Letter

This letter and attachments represent Powertech (USA) Inc.'s (Powertech's) written comments on the Draft Class III Area Permit for the Dewey-Burdock Project issued for public comment in March 2017. The written comments pertain to the draft permit, Draft Class III Area Permit Fact Sheet, Draft Aquifer Exemption Record of Decision and other supporting documents, including the Draft Cumulative Effects Analysis and Draft Environmental Justice Analysis. Following are general comments followed by specific technical comments (Tables 1 through 5) and additional comments included with proposed alternate solutions for several draft permit conditions (Attachments A-1 through A-10). References are provided as PDF files in Attachment B.

Figure A3-1. Dewey Wellfield 1 Potential Post-Restoration Groundwater Monitoring Wells.

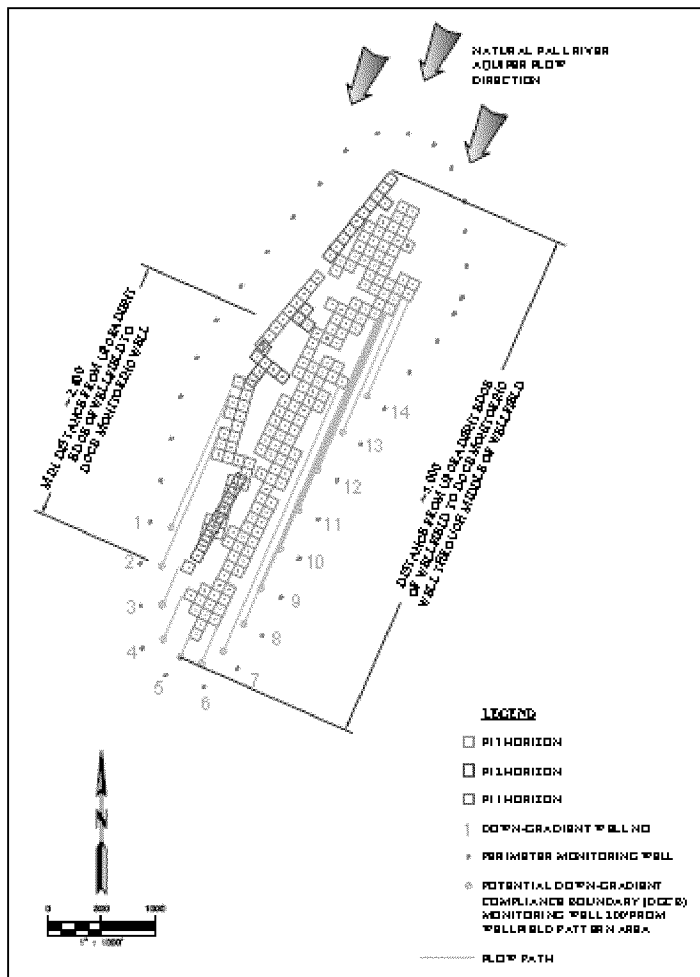
Figure A3-1 shows the approximate configuration of Dewey Wellfield 1, as depicted in Plate 7.1 of the Class III permit application, along with the natural groundwater flow direction from Figure 5.2 in the Class III permit application. This figure shows that the natural groundwater gradient closely follows the longitudinal wellfield axis, much more so than what is depicted in Figure B4 in the Draft Class III Area Permit. The result is that the distance along the natural groundwater flow path between the wellfield and potential DGCB monitoring wells is much farther than the offset distance of the DGCB wells from the wellfield.

Given that Dewey Wellfield 1 would be about 4,700 feet long, the travel time from the upgradient edge of the wellfield to potential DGCB monitoring wells would be hundreds of years for any well. Figure A3-1 shows that the minimum distance would occur for potential DGCB monitoring well location 2, southwest of the wellfield. Even this minimum distance is more than 2,600 feet, corresponding to a travel time of 400 to 500 years. If it were necessary to inject a tracer at the northernmost point in the wellfield, such that it would travel through the entire wellfield en route to a DGCB monitoring well, it would have to travel a distance of about 5,000 feet. This would take about 800 years under natural groundwater flow conditions. Clearly such travel times are technically infeasible regardless of how far the DGCB monitoring wells are placed from the wellfield.
